APPLICATION NO.	FILING DATE	FIRST NAMED INVENTOR	ATTORNEY DOCKET NO.	CONFIRMATION NO.
10/674,198	09/29/2003	James Patrick Clinch	140/40652/O&T 975	2676
279	7590	07/15/2005	EXAMINER	
TREXLER, BUSHNELL, GIANGIORGI, BLACKSTONE & MARR, LTD. 105 WEST ADAMS STREET SUITE 3600 CHICAGO, IL 60603			MITCHELL, KATHERINE W	
			ART UNIT	PAPER NUMBER
			3677

Office Action Summary	Application No.		Applicant(s)	
	10/674,198		CLINCH ET AL.	
	Examiner		Art Unit	
	Katherine W. Mitchell		3677

DETAILED ACTION

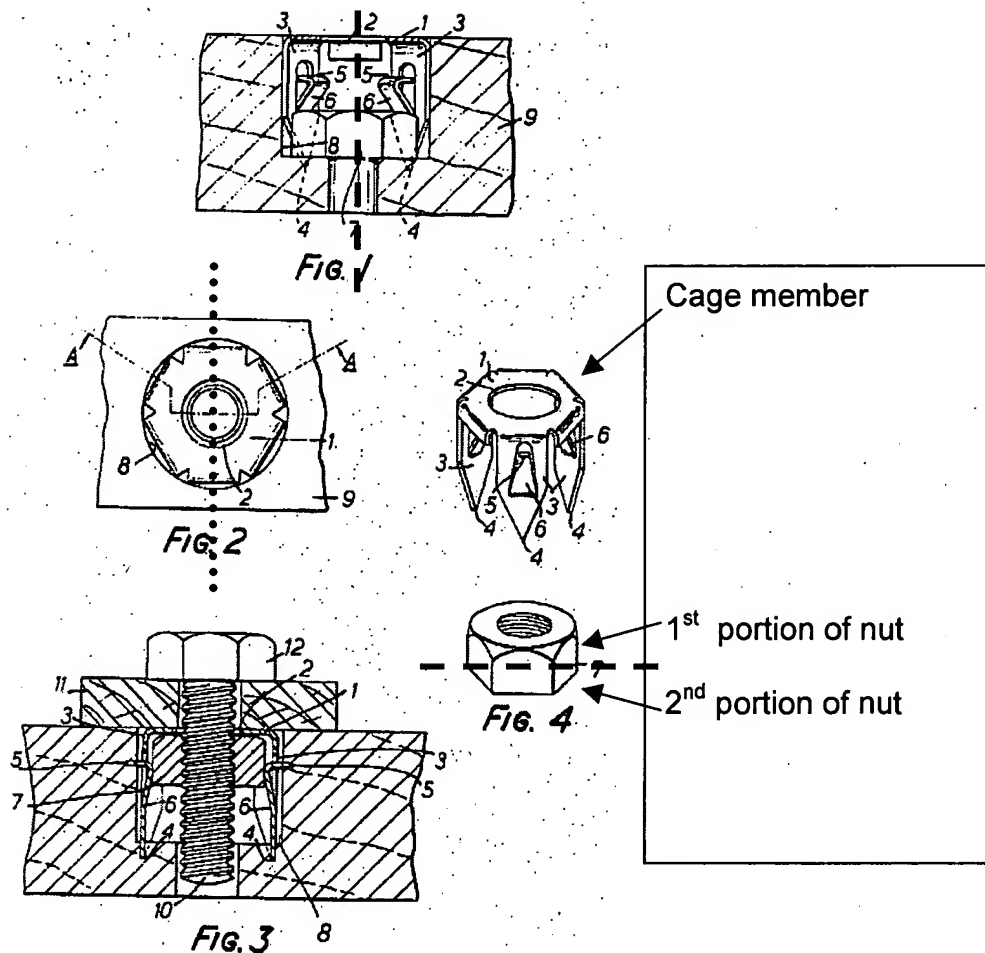
9. Claims 1-3,5-8,10-12,14-15, 19-20, are rejected under 35 U.S.C. 102(b) as being anticipated by Parkin USP 3451455.

Re claims 1 and 10: Parkin teaches a cage member (upper item in Fig 4) engageable with nut 7 having first and second portions and an aperture extending at least partially therethrough, (note that applicant is not claiming the nut, and a nut is capable of having distinct first and second portions. **However, further regarding claim 10**, the nut of Parkin can be considered to have a 1st portion [upper section in the figures, having the tapered sides] and a 2nd portion [lower section without taper]) thereby providing a cage nut assembly, said cage member comprising:

A body configured to encage the nut and having an aperture configured to allow access to the aperture of the nut member when the nut is encaged by cage member,

Said body defining a base portion (1) and at least one wall portion (3) and configured to engage the nut first portion such that the nut second portion does not come into contact with either the base or said at least one wall (Fig 1- notice that neither portion of the nut contacts the base or at least one wall, and in Fig 3, the 2nd portion does not contact the base or a wall 3), said body provides a limited range of nut movement in at least one dimension (axially along what could be called the bolt axis - see dashed line by examiner in Fig 1 above, although there is slight radial movement

Re claims 2-3, 5, 11-12,14: Said upper portion comprises at least one arm (6). Looking at Fig 2, note that there are at least two arm portions (6) which are positioned on opposite sides of a plane that bisects the base (see Fig 2 and examiner-drawn dotted line for plane), thus they are positioned opposite one another. The arms define an opening sized to receive the nut member therethrough when the nut 1st portion is engaged by said 2 arm portions (See Fig 3). Examiner notes that applicant did not require the arm to extend **directly** from said base.

Re claims 6,15: Fig 1 shows each arm 6 with a generally "C" shaped portion, and forming an opening between opposite arms.

Re claims 7,19: Looking at the difference in arm 6 between Fig 1 and Fig 3, it is clear that it is inherently flexible.

Re claims 8,20: As best understood, at least one arm portion can be moved (see Fig 1 and 3 comparison of arm for movement) to allow the 2nd portion of the nut member to be positioned above said base (entire nut is always above said base). Nut is between at least one wall portion of said body and something - an opposite wall.

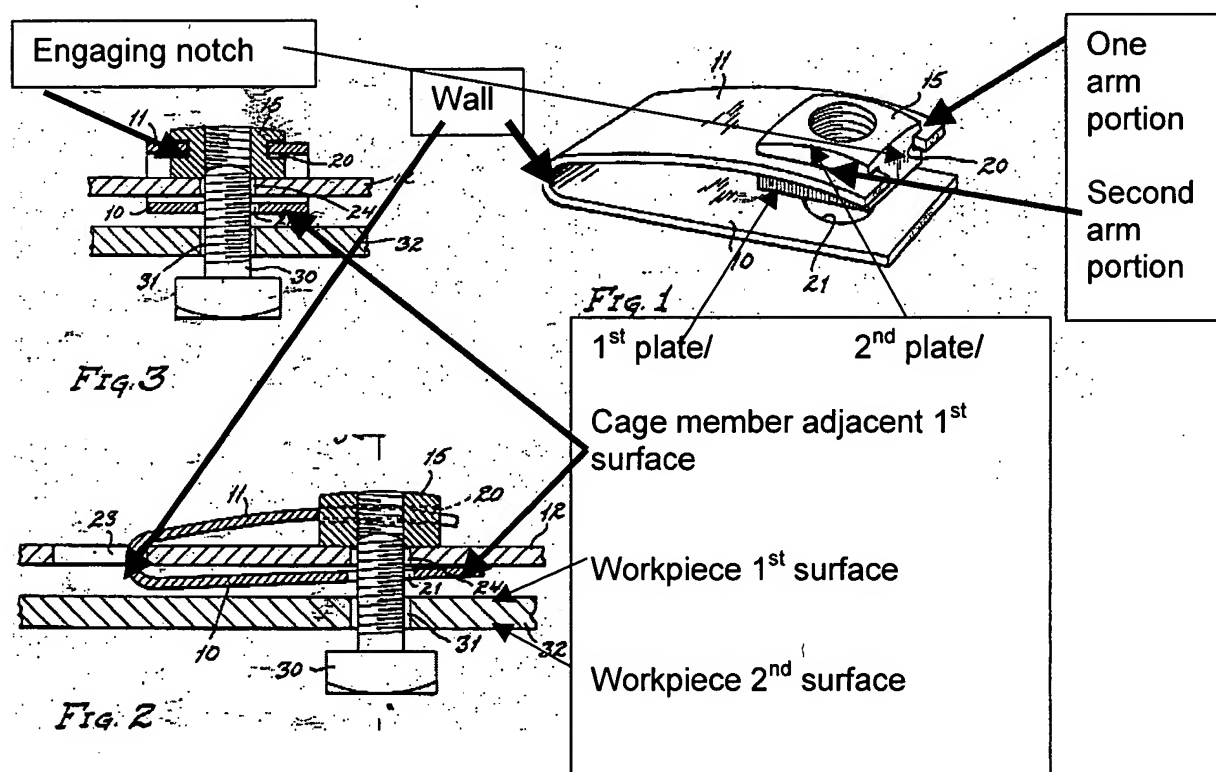
Re claims 1,2,3, 7,8,10,11,12,19,20: Tinnerman 342 in Figs 1-3 teaches a cage member and nut assembly, said nut (15) having a 1st and 2nd portion (see marked up

drawings below) enclosed by a cage member (10/11) which has a body configured to engage the nut member such that the nut member is encaged. The cage further comprises a body (11/10), and "11" is considered the upper cage/arm portion, and "10" is the base. The wall is labeled by examiner in drawings below. The nut engagement is such that the 2nd portion (same as the portion labeled "1st plate" below - looking at the drawings as oriented, it is the "lower" part of nut below "11") of the nut does not come into contact with either the base or the wall. Figs 1 and 3 shows a limited range of motion in at least one dimension. The body provides a limited range of nut movement in at least one dimension (axially along what could be called the bolt axis - although there is slight radial movement also).

Further Re claims 3 and 12: As shown in Fig 1, arm portion 11 forms two arm portions at the end as labeled by examiner in drawings below. These two arms are opposite each other.

Further Re claims 8 and 20: As best understood by examiner, the at least one arm 11 can be moved to allow nut 2nd portion to be positioned over base and between the wall and something - in this case the very end extension of the arm 11 past the notch.

Re claims 22 and 29-30 and 34-35 and 39-42: Tinnerman '342 in Figs. 1-3 teaches a nut (15) enclosed by a cage member (10/11) which has a body configured to engage the nut member such that the nut member is encaged. (Fig 1 and 2) "11" is considered the upper cage portion, and engaging notch (best shown in Fig 1 and 3) will inherently serve to suspend the nut off the base.

Re claim 32,37: The body further comprises at least one wall (see label by examiner above), and Figs 1- 3 show the nut engaged such that the nut does not contact at least one wall.
